Comments on the validation of Project ‘Replacement of electricity generated by existing 4 subcritical units of 120 MW of Koradi TPS by 1 unit of 660 MW based on supercritical technology, India’

JUNE 8, 2011

Indian Steam Coal Prices 2001-2008

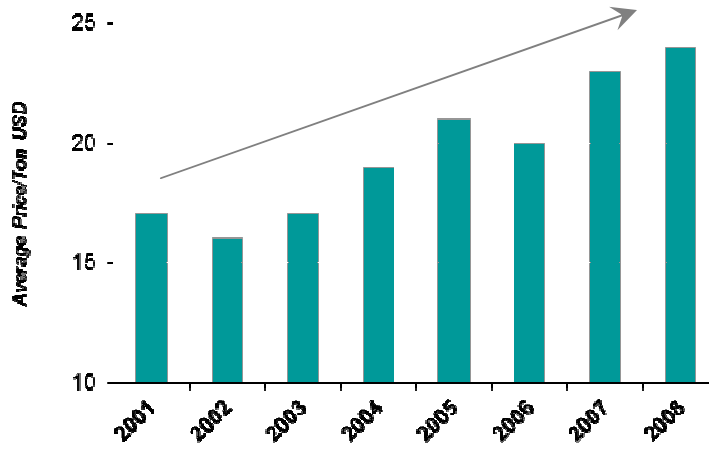
The PDD's sensitivity analysis is not robust to reasonable variations in critical assumptions, because it only varies coal prices by +/- 10 percent. In fact, prices have fluctuated by as much as 100 percent in recent years in the Indian market, and much more in the international markets. (see graphs, below). To date, coal plant operators have been shielded from the volatility of global markets by the fact that Coal India has sold its outputs to power producers at far below global prices to keep electricity prices down. However, domestic shortages have driven up coal imports over the last several years, increasingly exposing domestic power producers to the more expensive and more volatile global markets.⁸⁰ Moreover, Coal India's subsidies are increasingly unsustainable.⁸¹ It raised prices by 12 percent in February, 2011 but excluded the power sector.⁸² Future price hikes will likely cover all sectors and will recur every 18-20 months.⁸³ In the face of these trends, it is fanciful to assume that coal prices will not fluctuate more than 10 percent from the base case over the course of the ten year project period.

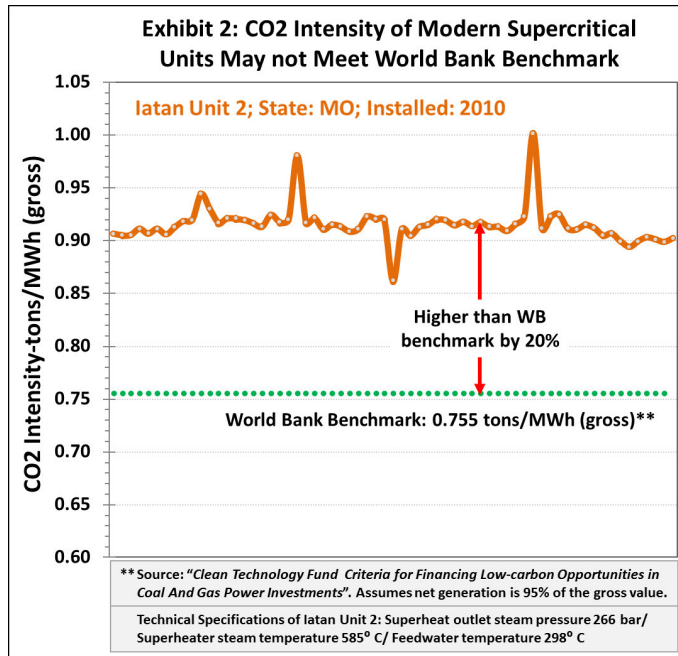
The amount of CO₂ emissions that will be released from a given coal-fired unit can vary widely depending on a number of site specific factors. These include coal quality, heating value, site conditions, condenser pressure, plant design, and the addition of pollution control equipment such as FGD or SCR.¹¹¹ Of these factors, variability in the coal used poses a particular challenge in predicting the CO₂ emissions factor of an individual coal plant. Coal can vary in quality and characteristics even for coal of the same category.¹¹² This makes it impossible to predict an exact amount of CO₂ emissions for supercritical technology unless the project was minemouth or pithead utilizing coal from the exact same source year after year.¹¹³ For example, an individual unit can fluctuate anywhere between 0.86 tons CO₂/MWh

to 1.01 tons CO₂/MWh depending upon a variety of factors including coal quality (see chart below).¹¹⁴

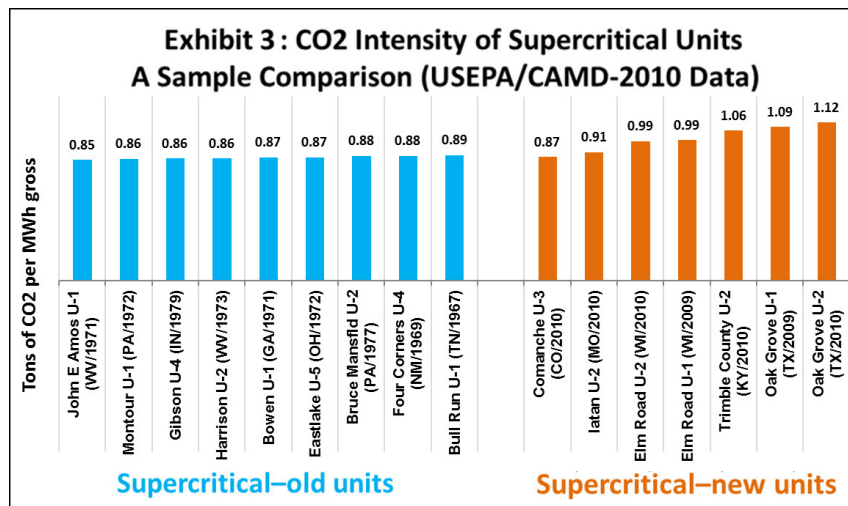
The issue of coal quality is particularly important for determining CO₂ emissions performance for Indian plants, regardless of whether the plant is subcritical, supercritical, or even ultra-supercritical.¹¹⁵ Indian coal is particularly poor, with a high ash content and low calorific value. As a result, it produces lower emissions factors than those assumed in ideal conditions with higher quality coals.¹¹⁶ Perhaps more importantly, it remains unclear whether it is the supercritical technology or the quality of coal that has a larger effect on CO₂ emissions intensity.¹¹⁷
